**CITY OF ROCKVILLE PLANNING DIVISION
STAFF REPORT**

February 12, 2004

SUBJECT: Use Permit Application
USE2003-00670

Applicant: Federal Realty Investment
Trust/City of Rockville/RD
Rockville, LLC

DETAIL #4 - MARKET STREET: TYPICAL

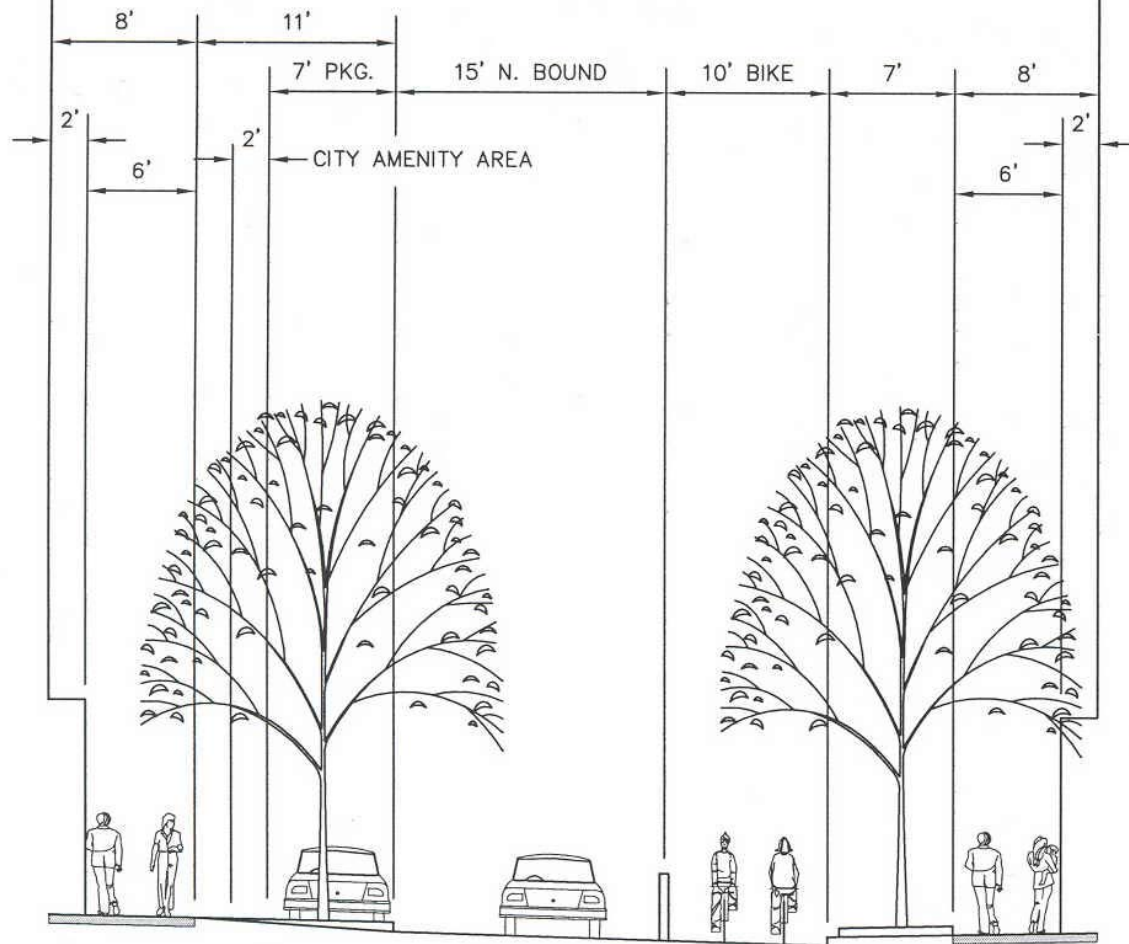
The street referred to as "Market Street" will be a one-way northbound street. As such, the carriageway will be 14 feet wide plus a 10-foot wide, two-way bike lane on the east side of the street. The public right-of-way will be from back of curb to back of curb (26 feet wide). The sidewalks will remain in private ownership with public access easements. All private areas will be maintained by the CMD.

The bike lane and traffic lane will be separated by a series of bollards and planters, all of which may be removed for major events that will close the entire street. The bollard sleeves will be placed every 10 feet within the first two feet of the bike lanes adjacent to the carriageway. The intent is to intersperse the bollards with two foot by four-foot planters that are twenty-four inches tall. This will allow flexibility of design and spacing as demands dictate. In addition, the bikeway will be concrete, while the street surface will be asphalt, providing a further visual difference.

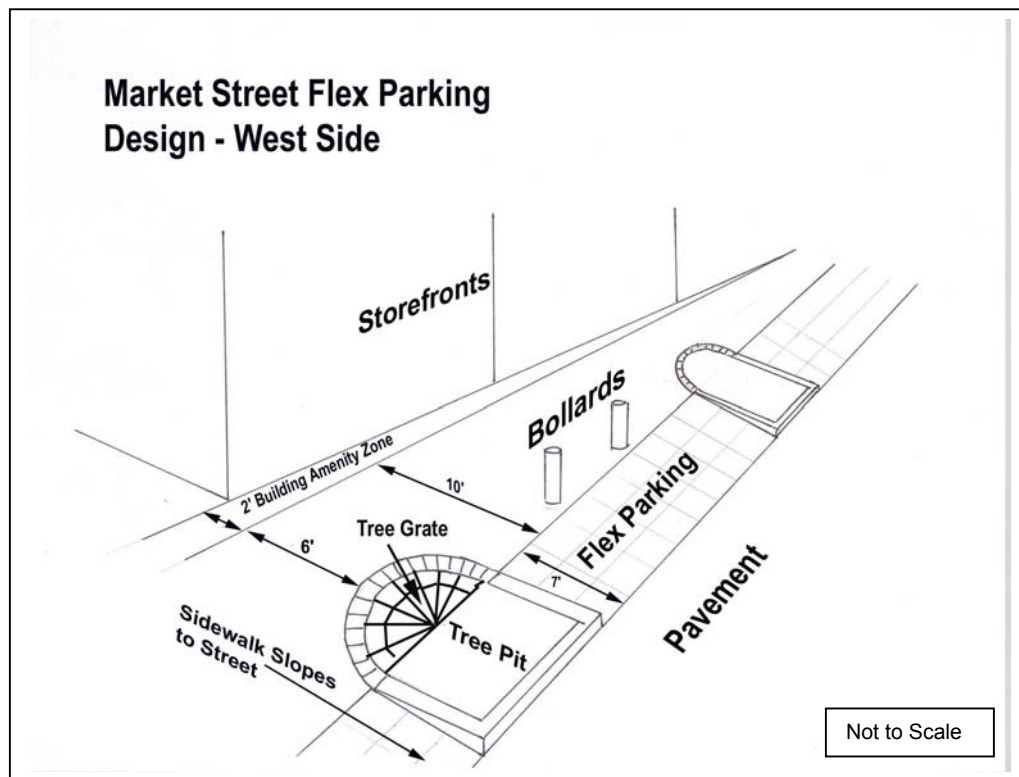
There will be on-street parking on the west side, with the spaces appearing as extensions of the sidewalk between the street trees. This “flex” parking system is intended to allow the extension of the shopping and dining activities up to the street. Since the parking spaces are within the private ownership area, some can be used for commercial activities such as outdoor dining. The overall design has the effect of expanding the sidewalk, making the pedestrian the dominant feature on the street. The formal sidewalk surface is proposed for a herringbone brick, while the flex spaces will be scored concrete. A half-round tree grate will be installed at the apex of the individual tree pits to expand the usable pedestrian area if a suitable grate and mounting bracket are available. Staff recommends that no more than five of the flex spaces be used for dining, with the remaining being available for parking. The following diagram illustrates the general arrangement of this “flex” area.

29. There must be a three-foot access way from the curb to the pedestrian zone at a minimum spacing of every 4 parking spaces as approved by DPW. This area must remain free of obstacles to allow access between parked cars and the pedestrian zone.

DETAIL #3 - MARYLAND AVENUE: TYPICAL
Scale: 1" = 8'

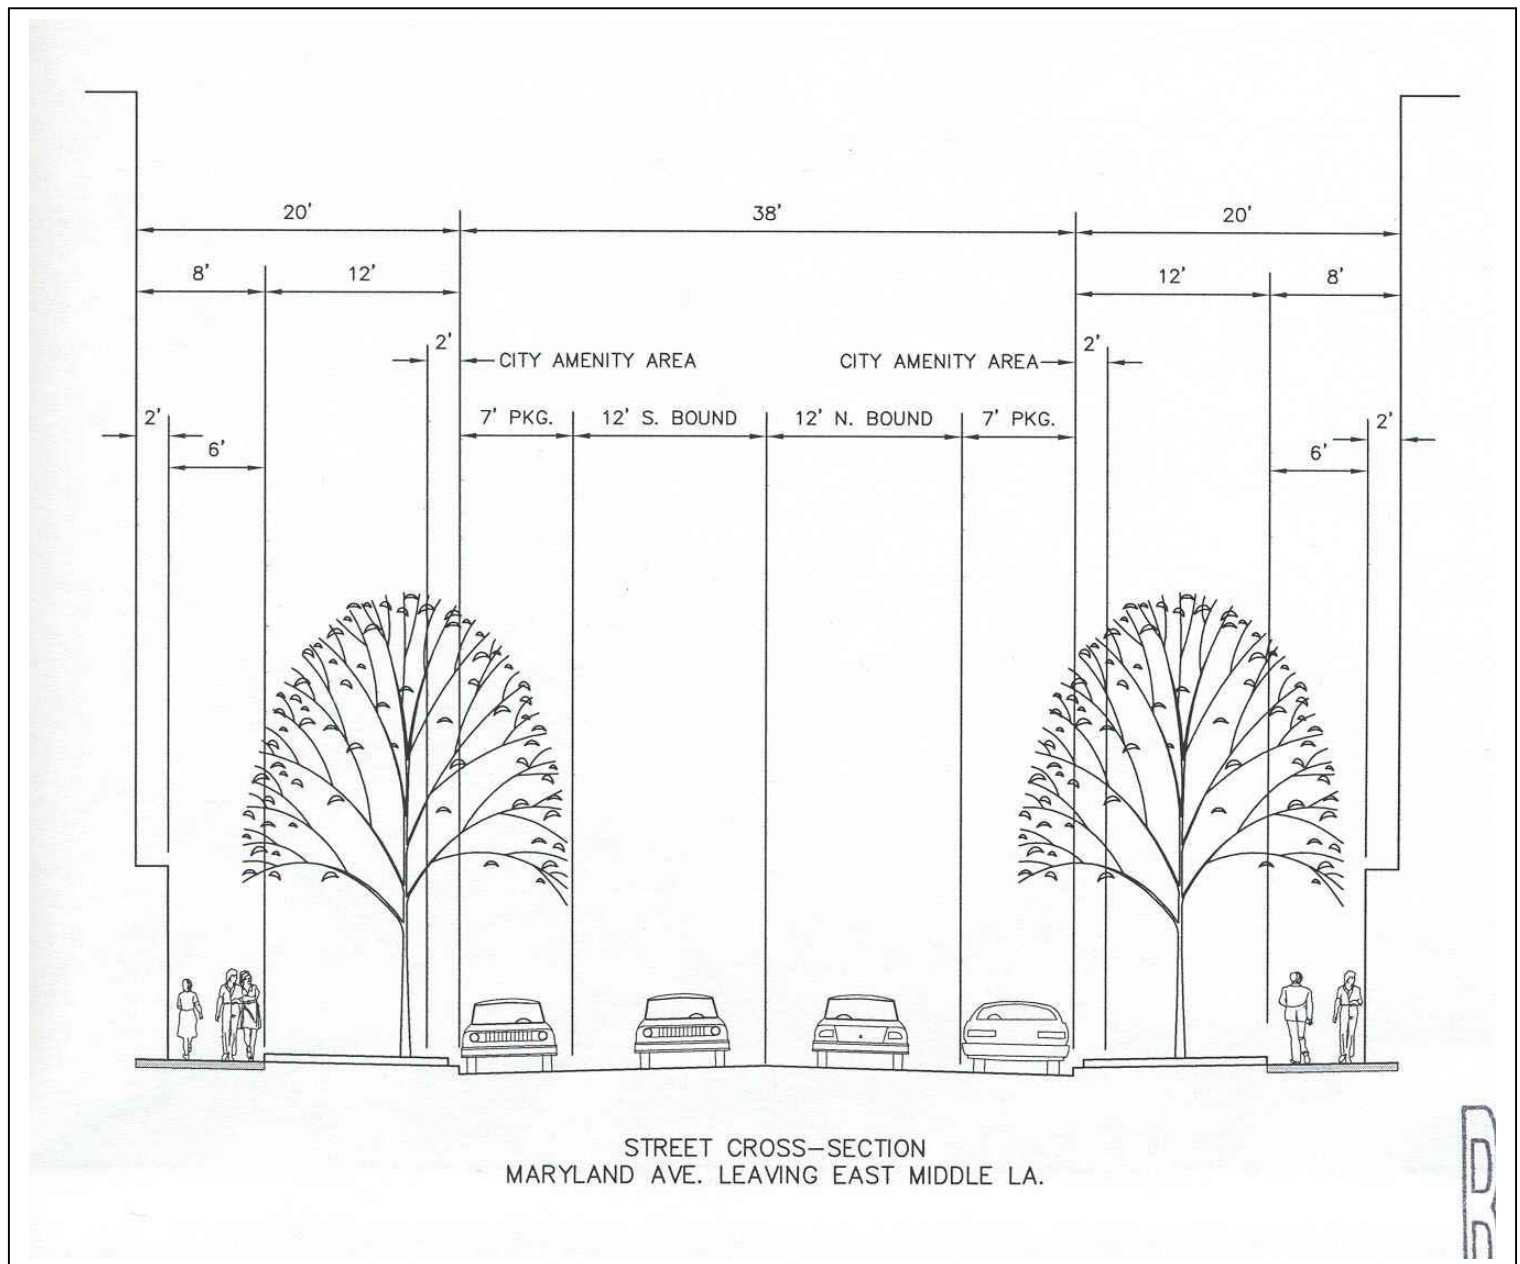
Maryland Avenue will be a two-way street, with a conventional curb-and-gutter design and asphalt surface. The public right-of-way will be from back of curb to back of curb, in this case 40 feet wide. As with "Market Street" the surface will ramp up at the plaza. The sidewalks, which will be on private property with public access easements, will be 12 inch x 12 inch tumbled concrete pavers with integral color, divided by concrete divider strips. The sidewalk along the library will include sinuous curves, to reflect the design of the library building. This will allow for small green pockets that can contain benches and some landscaping along the building wall. The street trees are proposed to be Allee' Elms. Consistent with "Market Street", these trees will be 6+ inches in caliper.

- b. Add trees to the medians on Beall Avenue and E. Middle Lane where feasible.
 - c. Adjust the spacing of street trees on Maryland Avenue next to the library so that trees are planted in the wide spots of the sinuous planting pits.

STREET CROSS-SECTION
BEALL AVE. APPROACHING HUNGERFORD DR.

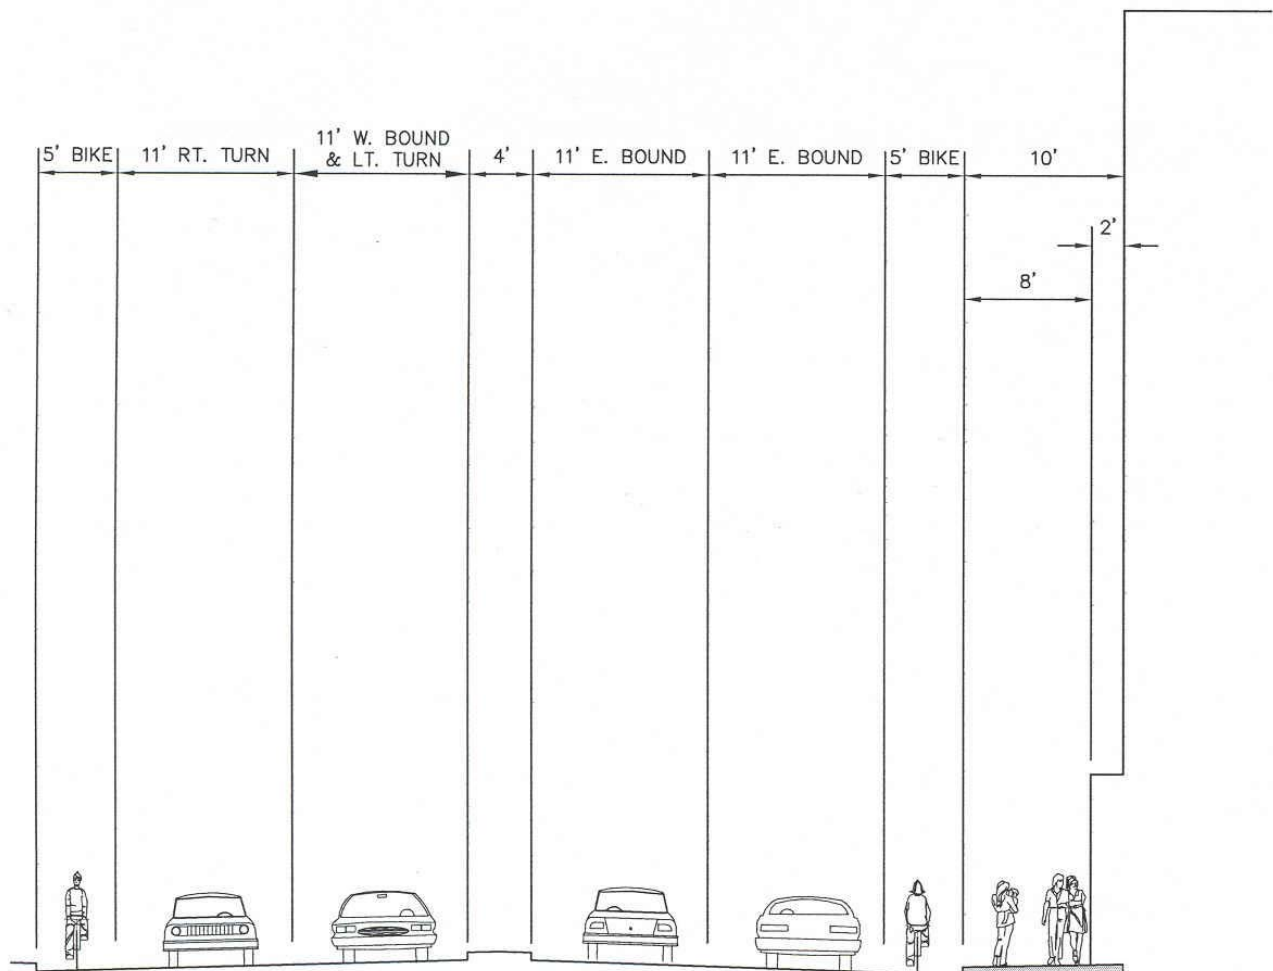
Between North Washington Street and Maryland Avenue, the sidewalk is at least six feet wide with a 7-foot tree lawn. In front of Block 4 the sidewalk is 10 feet wide but does not include street trees. The section of this street between Maryland Avenue and Hungerford Drive has insufficient right-of-way to accommodate the full 15-foot pedestrian amenity area recommended in the guidelines in the area between the proposed CVS drug store drive-thru entry and Hungerford Drive. In order to achieve the full 15-

foot pedestrian amenity area width, the footprint of the building on Block 4 would have to be reduced.

The applicant will also be required to improve Beall Avenue for its full width, including paving and medians. This is in conjunction with the relocation of the 16-inch water main below the street. The City and FRIT are examining the possibility of building Beall Avenue out to its full planned width.

21. The applicant will design the north side of Beall Avenue between North Washington Street and Maryland Avenue. DPW may require applicant to construct the northern half of Beall Avenue pending future developer contribution.

STREET CROSS-SECTION
EAST MIDDLE LA. APPROACHING NORTH WASHINGTON ST.

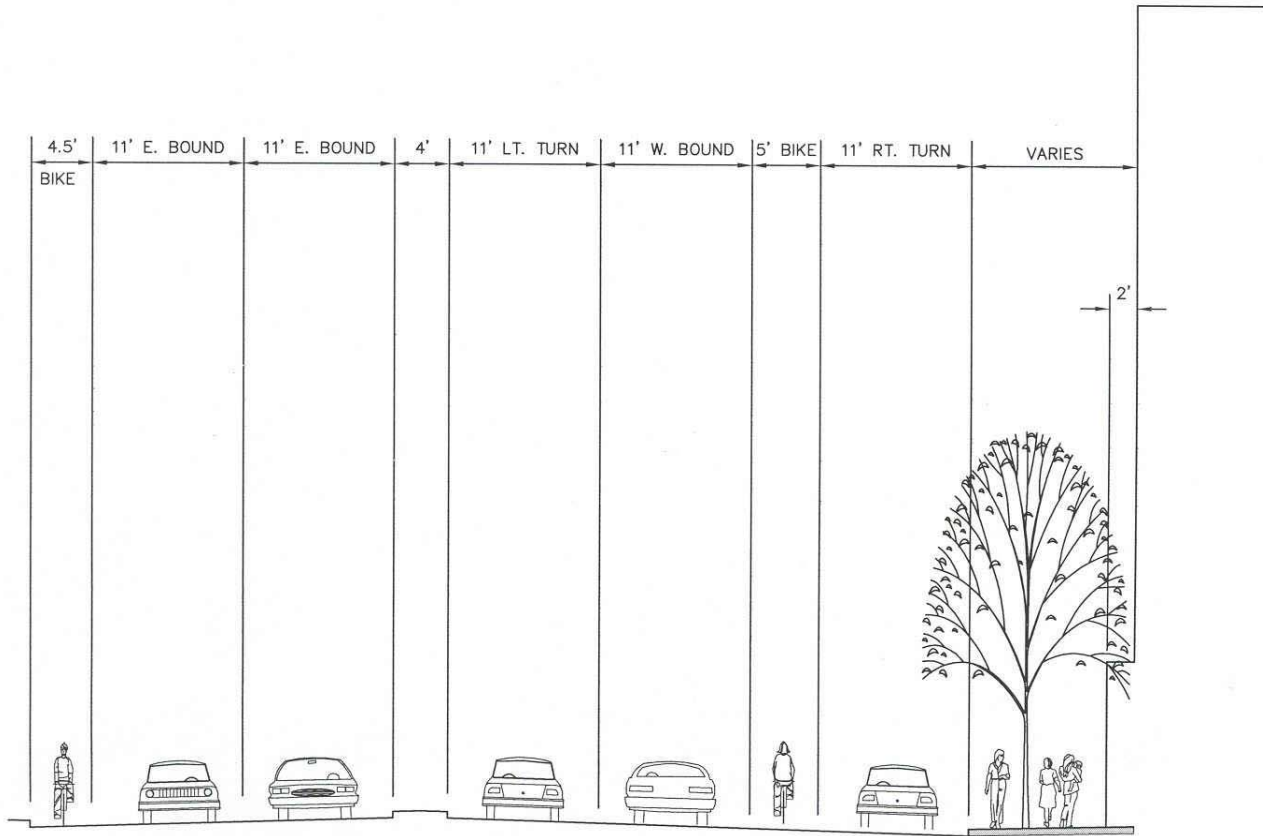
Middle Lane will be widened to 4 lanes with a median by moving the existing curb northward. The area between the new curb and proposed buildings ranges from 12 to 15 feet. In areas where the width is less than 15 feet, the outdoor dining areas will be reduced and the two-foot building expansion zone must remain clear to maintain a minimum 6-foot wide sidewalk between the buildings and the trees (including the tree grates). A building expansion zone can utilize the two additional feet as long as the 6-foot wide sidewalk is able to be maintained. The Block 5 frontage meets the 15-foot pedestrian area guideline.

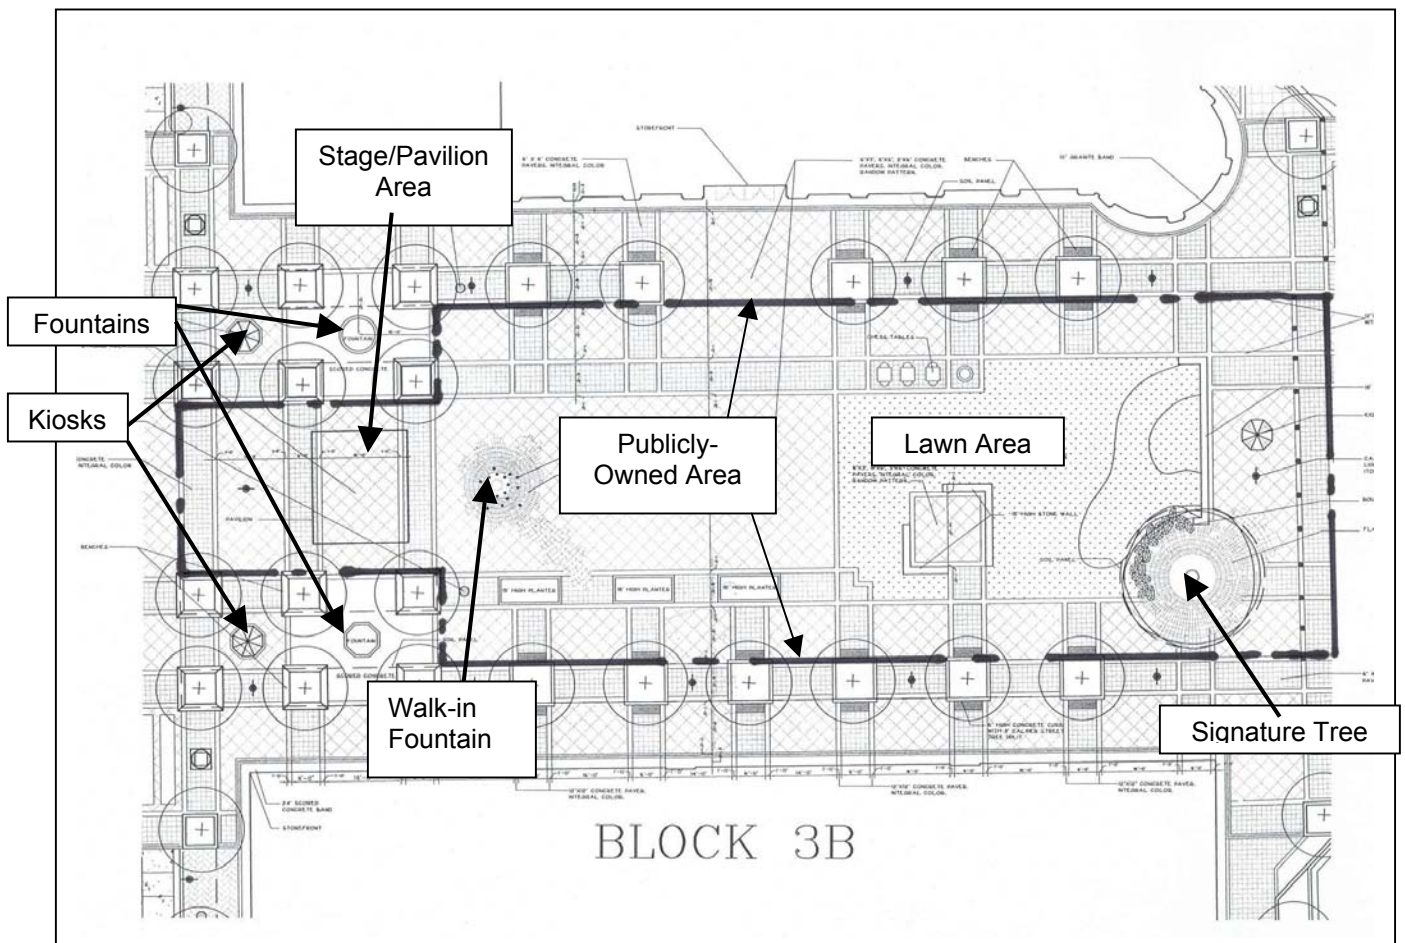
The plaza is intended to be used for a variety of events. As such, a removable pavilion will be designed that can be installed at the west end. Tie-downs will be permanently installed in the pavement to support the pavilion when it is erected. The applicant also proposes installation of two permanent kiosks that would flank the pavilion location. In the middle, a jet fountain is proposed, wherein the nozzles are flush mounted below the surface and spray upwards for people to walk through. The surface treatment will be a combination of colored tumbled concrete pavers, scored concrete, and natural stone around the fountain. On the east half of the plaza, a lawn area is proposed. There will also be a sitting area in this location, and small tables along the north edge. The east end of the lawn area rises up 18 inches to a low wall that demarcates the east end. Next to the southeast corner of the lawn area will be the location of the signature tree.

The central portion of the public plaza will be in public ownership. This encompasses an area of about 77 feet by 235 feet, or 18,095 square feet. If the street areas on both ends are also included (as for major events that close both streets), the total usable area (77' x 329') is about 25,333 square feet, or about .58 acre. The figures do not include the areas next to the buildings that are to remain private. The building-to-building distance is 120 feet. If that is included in the total area, the size becomes 39,480 square feet, or .91 acre.

14. Easements shall be required for all streets where public works structures/facilities are located outside of the right-of-way.
 15. No permanent structures to be located above the SWM facility located within the plaza except as may be approved by DPW. Access manholes/grates shall be located outside the grass area and within the hardscape area of the plaza where feasible.

- d. The proposed 12-inch Weeping Beech in the plaza will be maintained by the CMD and replaced if so determined by the City Forester for a period of 12 years.
